Planning Commission

Revised Regular Meeting Agenda

January 8, 2024 | 6:30 PM

SUBJECT: Landscape Plan, Peachtree City Orthodontics, 101 Gates Entry

DRAWING NO.
L100

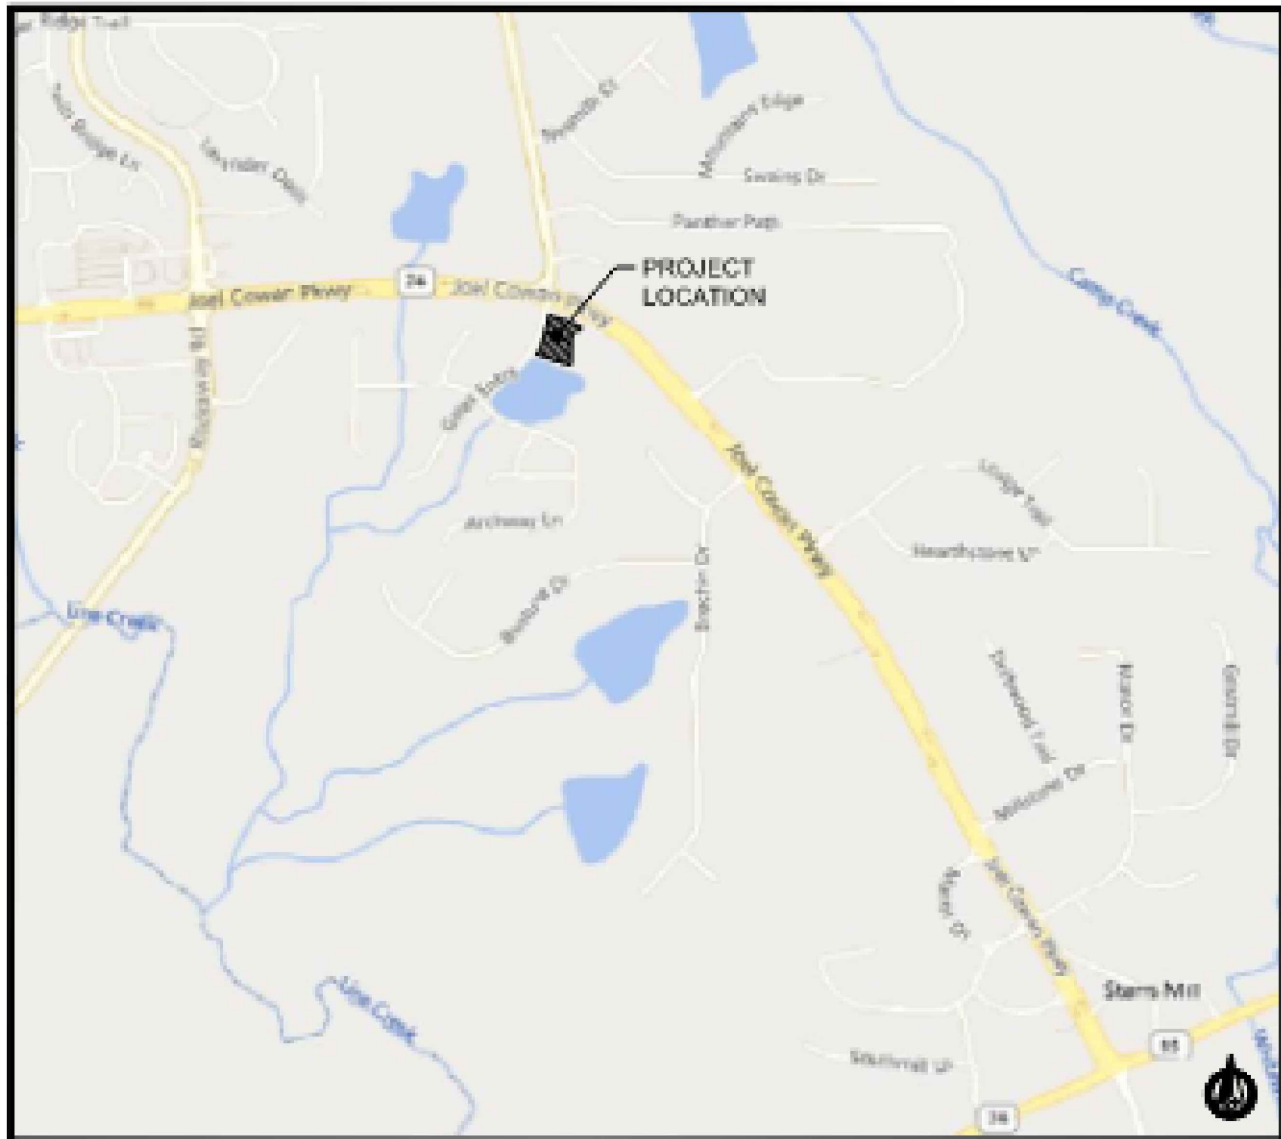
Staff is of the opinion the proposed landscape plan for Peachtree City Orthodontics at 101 Gates Entry meets the Landscape Plan requirements of the City ordinances and recommends approval.

Based on the total amount of impervious surface on the parcel (20,142 SF), the landscape ordinance requires at least 60 caliper inches of canopy trees and 40 caliper inches of understory trees. Per Section 1110(e) of the Land Development Ordinance (LDO), undisturbed tree-save areas may be used to offset the number of tree inches required on a site. No tree-save areas were identified on the plan and the applicant is not requesting to use the Tree Fund alternative compliance option. The proposed plan meets the caliper inch requirement (see table below).

Per Section 1108 of the LDO, the perimeter of all parking lots shall be landscaped with evergreen plant material that is a minimum of 24 inches in height at time of planting. While they are evergreen, the proposed Loropetalum and Indian Hawthorn located on the south side of the parking area will only reach 2-3' at maturity, However, Staff feels the selection is acceptable because the parking is not highly visible from the street or

the adjacent lot. In addition, the berm on the adjacent parcel is planted with fairly large evergreen trees which provides a nice screen between the office parcel and the residential neighborhood amenity.

DRAWING NO. C200

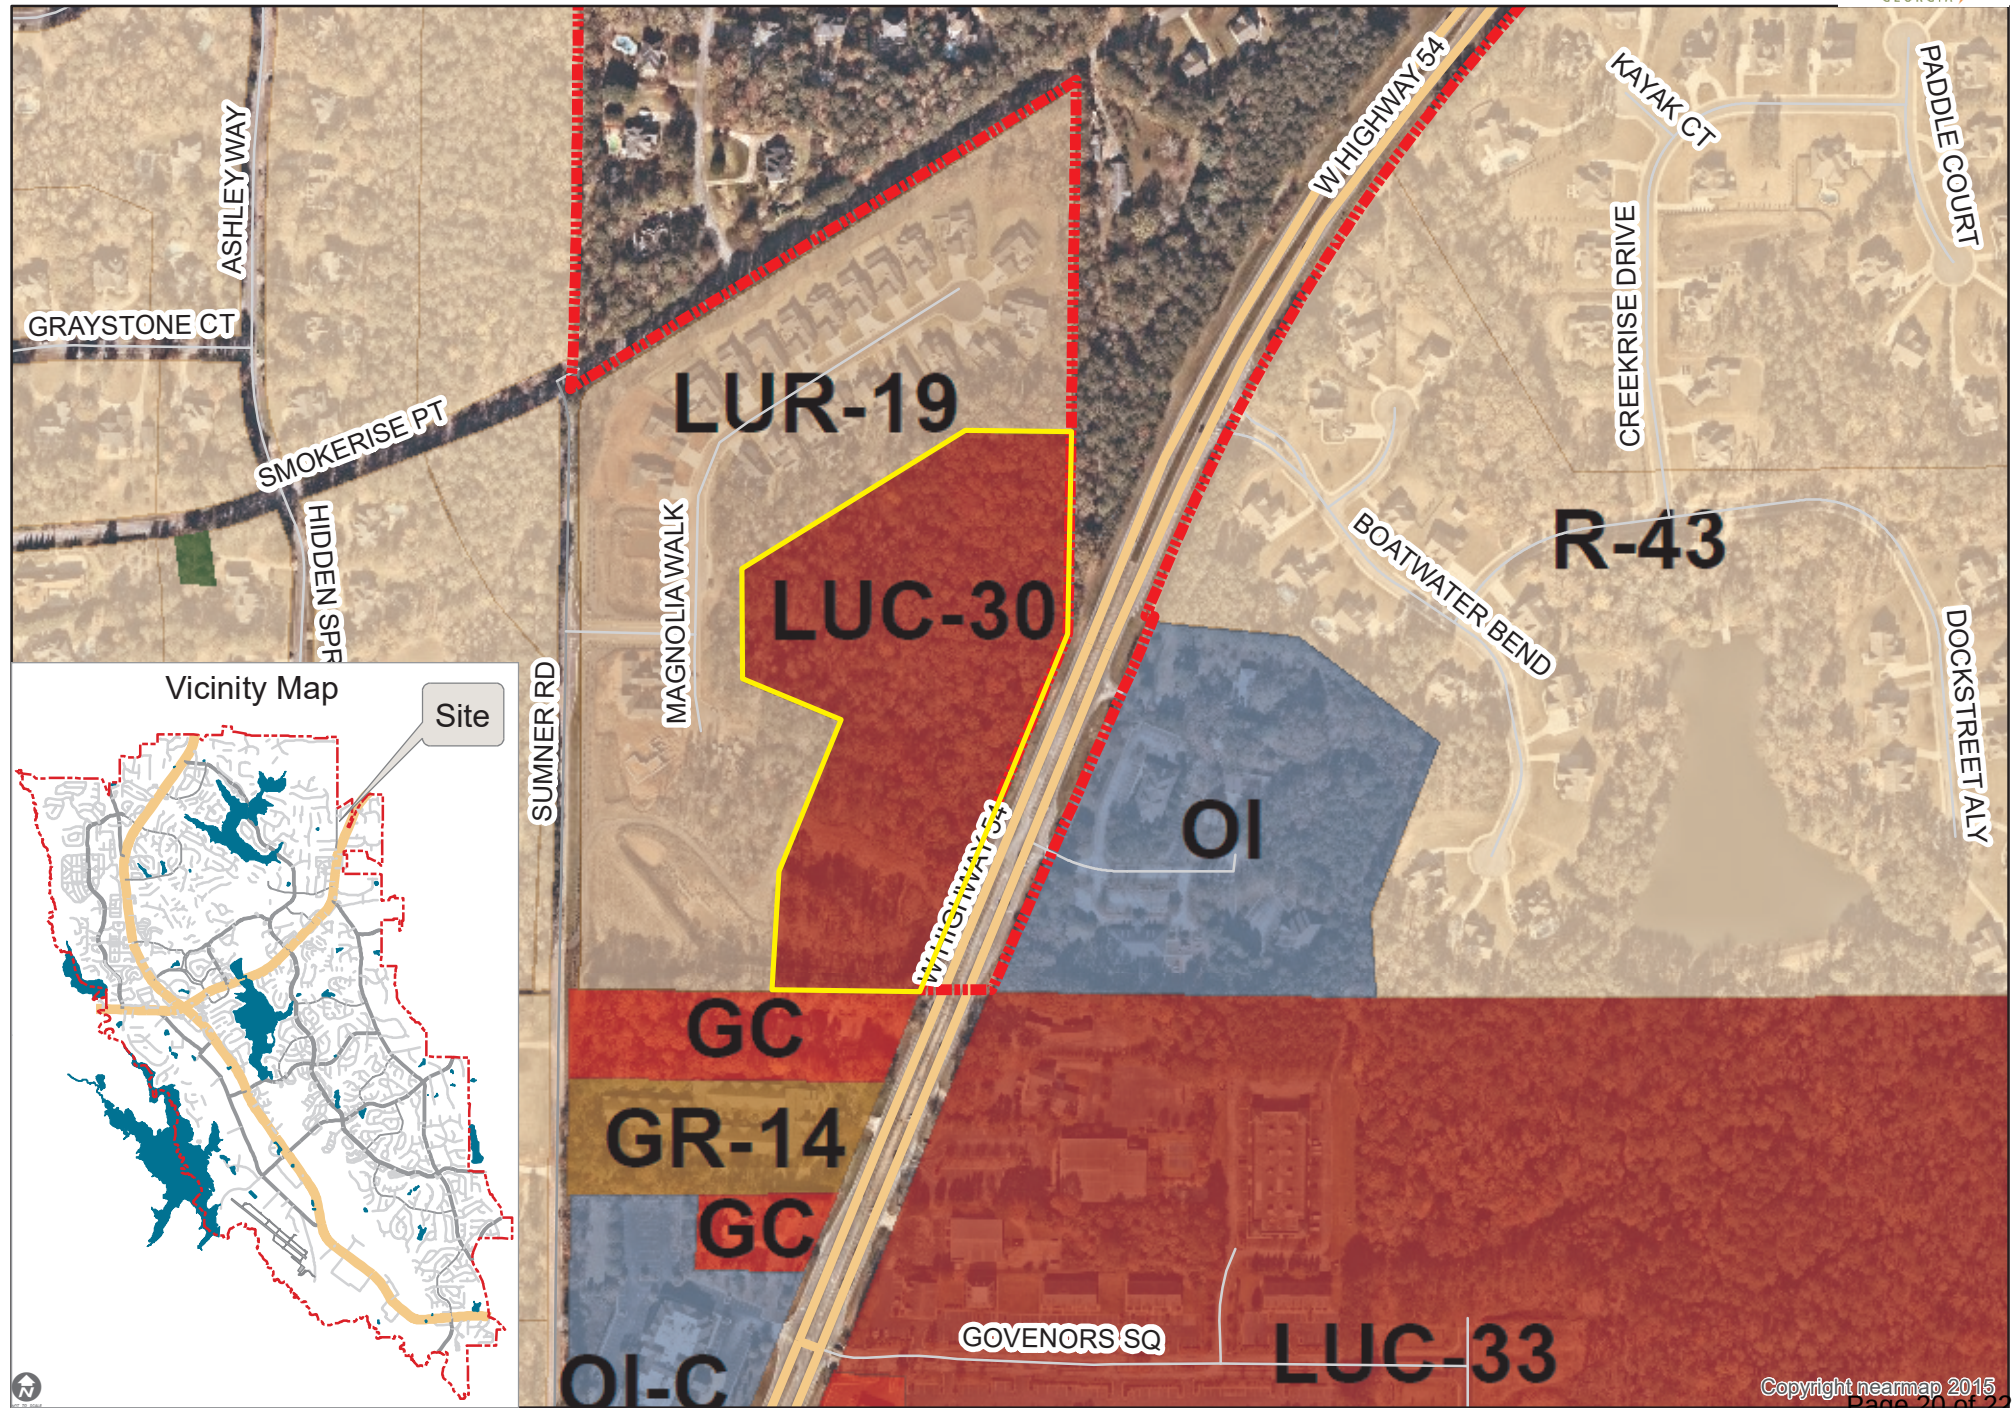
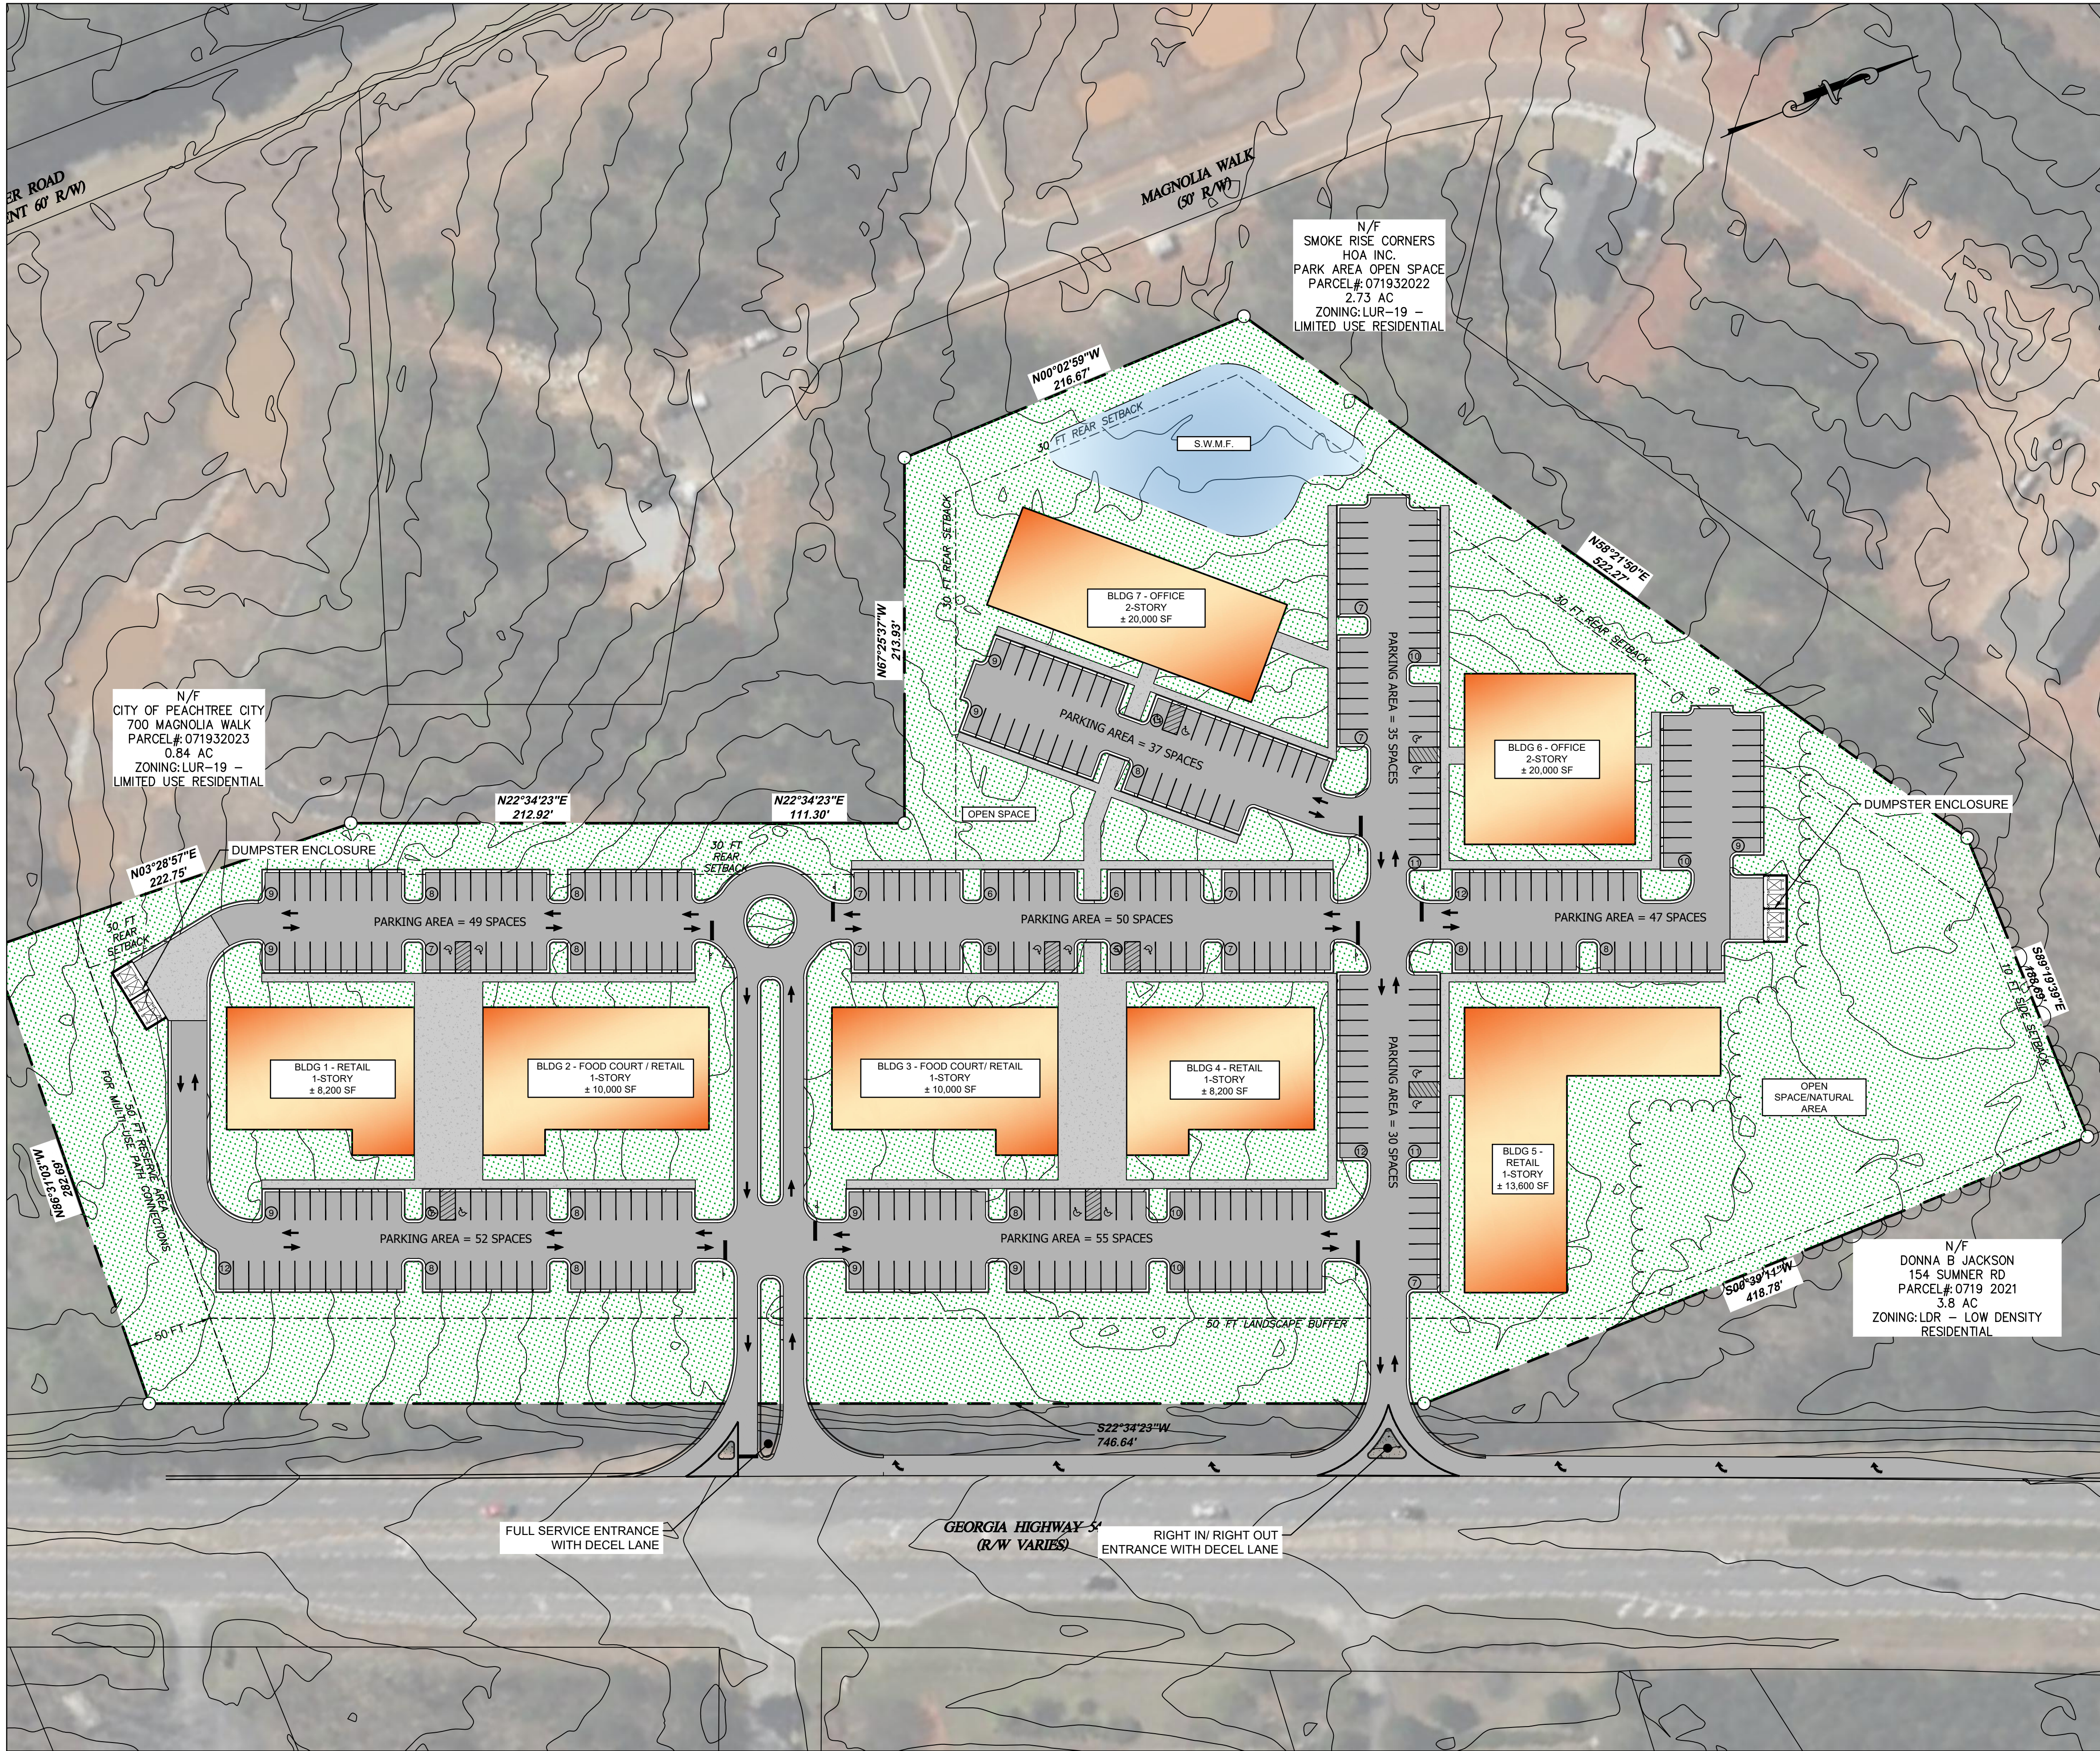
Staff is of the opinion the conceptual site plan for the Highway 54 West Development at 1941 W HWY 54 meets the City ordinances and recommends approval.

Because the property is not being subdivided, this requirement is calculated as a percentage of building area. 4.1 acres of office is equal to 45% of the land area while 4.8 acres of commercial is equal to 55% of the land area. The total building square footage proposed is 90,000 square feet with 55% dedicated to commercial uses (50,000 square feet) and 45% dedicated to office uses (40,000 square feet). Along with the 1.9 acres of open space, the proposed conceptual site plan satisfies the zoning requirements.

The proposal is for 363 parking spaces, which meets the minimum requirement of 327 spaces. The maximum parking permitted is 125% of the parking required, which equals 408 spaces. The proposal satisfies the parking requirements.

The buffer was approved at 50 feet for this LUC zoning district. The proposed development plan exceeds this requirement.
